APPLICATION NO.	FILING DATE	FIRST NAMED INVENTOR	ATTORNEY DOCKET NO.	CONFIRMATION NO.
10/595,416	04/17/2006	Christian Herlt	HERL0101PUSA	9015
22045	7590	06/28/2011	EXAMINER	
BROOKS KUSHMAN P.C. 1000 TOWN CENTER TWENTY-SECOND FLOOR SOUTHFIELD, MI 48075			LAUX, DAVID J	
			ART UNIT	PAPER NUMBER
			3743	
			MAIL DATE	DELIVERY MODE
			06/28/2011	PAPER

Office Action Summary	Application No. 10/595,416	Applicant(s) HERLT, CHRISTIAN	
	Examiner DAVID J. LAUX	Art Unit 3743

DETAILED ACTION

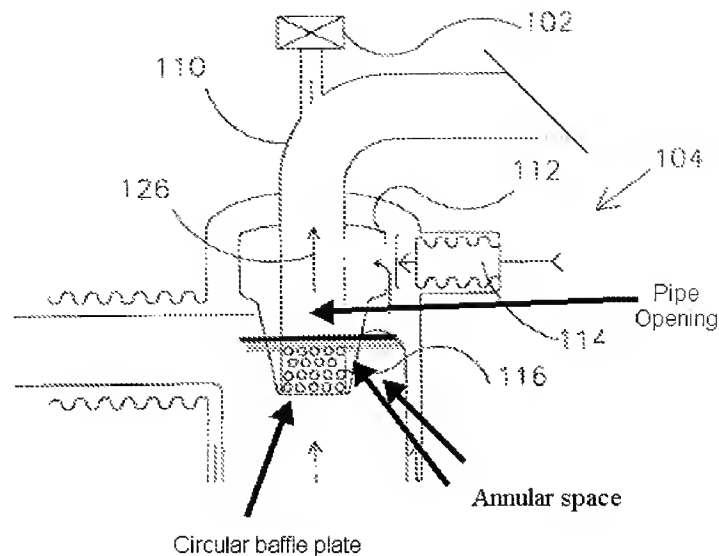
18. With regard to claim 5, '909 as combined with '165 further discloses a circular baffle plate is fitted below the opening of the pipe (see Fig. 6 reproduced in part below) in such a manner that a narrow annular opening ('165: 100) for the depositing of the fine ash particles between an outer wall ('165: 96) of the ash separator ('165: 16) and the baffle plate (centrifugal forces force ash to the outer portion of the separator (the annular space) while allowing clean gases to flow through the pipe).
